UNITED STATES PATENT AND TRADEMARK OFFICE

APPLICATION NO.	FILING DATE	FIRST NAMED INVENTOR	ATTORNEY DOCKET NO.	CONFIRMATION NO.
09/838,356	04/19/2001	Karl Jacob Haltiner JR.	DP-304959 (DEP-0197)	2480
22851	7590	03/08/2005	EXAMINER	
DELPHI TECHNOLOGIES, INC. M/C 480-410-202 PO BOX 5052 TROY, MI 48007			WILLS, MONIQUE M	
			ART UNIT	PAPER NUMBER
			1746

Office Action Summary

DETAILED ACTION

FIG. 1

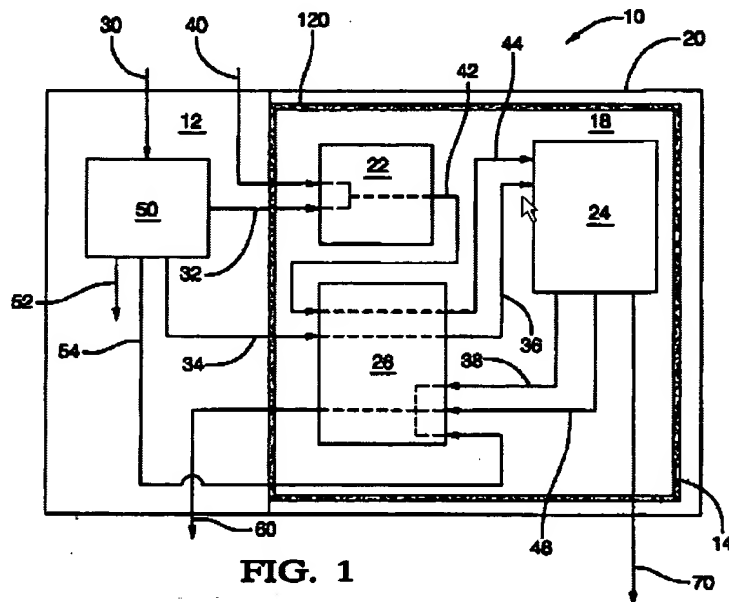
With respect to claim 26, Armstrong teaches a method of producing electricity in an auxiliary power unit of a vehicle comprising: adding a fuel (40) and a reactant (32) to a fuel reformer (22); producing a reformat (42) at said fuel reformer (22); introducing said reformat (42) to a fuel cell stack (24); producing electrical power at said fuel cell stack (24); sensing a reformer zone temperature at a reformer zone (18); determining whether said reformer zone temperature is at a first selected temperature range; and adding a first process (32) air flow to said reformer zone (18) if said reformer zone temperature rises above

said first selected temperature range. See Figure 1, and column 2, lines 1-5. As to claim 29, the first process airflow is controlled via a first air control valve. See column 3, lines 10-15.

As to claim 31, the method further comprises: sensing a hot zone temperature at the hot zone (26); determining whether said hot zone temperature is at a second selected temperature range; and adding a second process air flow to the hot zone if the hot zone temperature rises above the second selected temperature range (col. 2, lines 55-65).

As to claim 34, the method further comprises controlling the second process airflow via a second air control valve (col. 3, lines 10-15). With respect to claim 35, the method further comprises moving reformer air (42) to the hot zone (26). As to claim 36, the method further comprises moving hot air to a waste energy recovery unit (26).

Therefore, the instant claims are anticipated by Armstrong.
